Access Compliance Report

Public Rights-of-Way

(Curb Ramps)

Intersection ID: 28092	Main Street: TOM_SHORT_RD	Cross Street: WARWICK_LINKS_DR	Location: SW
ADA ID: D046EBDCDAF2	Ramp Type: PerpDiag	Initial Pass/Fail: Pass	Overall Compliance: No
Severity Score: 12.5			
Codes/Mitigation Info/Possible Solution		Field Measurements/Component Compliance

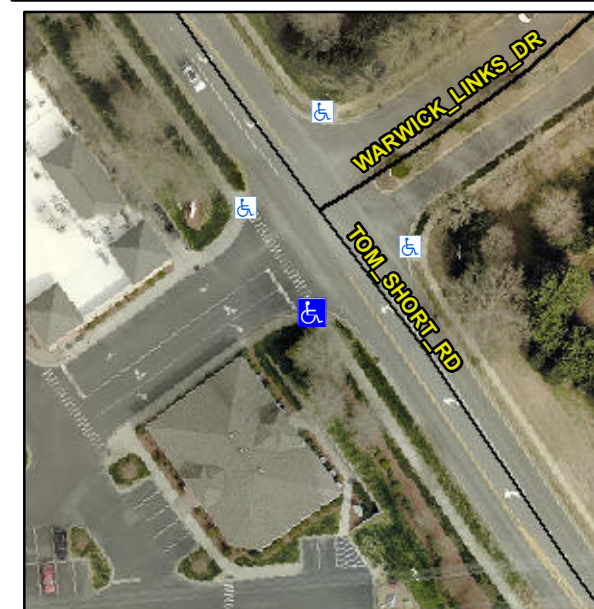
Not Found, R304.2.1, R304.2.2-Perp, R304.3.2-Para, R304.5.3, R305.1.4, R305.2

Compliance	Description	Data	Compliance	Description	Data
N/A	Ramp Length (in)	54.5	Yes	Ramp Slope (%)	7.1
Yes	Ramp Width (in)	53.5	Yes	Ramp XSlope (%)	1.4
N/A	Flare Type LT	Sloped	N/A	Flare Type RT	N/A
N/A	Flare Slope LT (%)	2.8	Yes	Flare Slope RT (%)	5.1
N/A	Flare Traversable LT?	Yes	N/A	Flare Traversable RT?	Yes
No	Landing Length (in)	N/A	Yes	DWS Provided?	Yes
No	Landing Width (in)	N/A	Yes	DWS Contrast?	Yes
No	Landing Slope (%)	N/A	Yes	DWS Length (in)	24.5
No	Landing X Slope (%)	N/A	No	DWS Full Width?	No
N/A	Landing Curb? (Y/N)	No	No	DWS Offset (in)	4.0
N/A	Shared Landing?	N/A			
Yes	Gutter Ponding?	No	Yes	Gutter Slope (%)	1.7
Yes	Gutter Lip Ht (in)	0.0	Yes	Gutter X Slope (%)	0.1
N/A	Painted X Walk1?	No	N/A	Painted X Walk2?	Yes
	X Walk 1 Direction	To NE		X Walk 2 Direction	To NW
N/A	X Walk 1 Width (in)	N/A	N/A	X Walk 2 Width (in)	60.5
	X Walk 1 Slope (%)	1.8		X Walk 2 Slope (%)	2.0
	X Walk 1 X Slope (%)	1.5		X Walk 2 X Slope (%)	1.4

N/A	Ramp inside XWalk1?	N/A	Yes	Ramp inside XWalk2?	Yes
	Road Slope (%)	1.3	N/A	Clear Space?	Yes
	Road X Slope (%)	0.9	N/A	Clear Space to XWalk (in)	N/A
Yes	Any Obstructions?	No	Yes	Storm Grate/Utility Hazard?	No
	Obstruction Type			Storm Grate/Utility Type	
		N/A			N/A
			Yes	Surface Condition? (G/P)	Good

Remove & Replace Curb Ramp With Two New Directional Ramps or Equivalent.
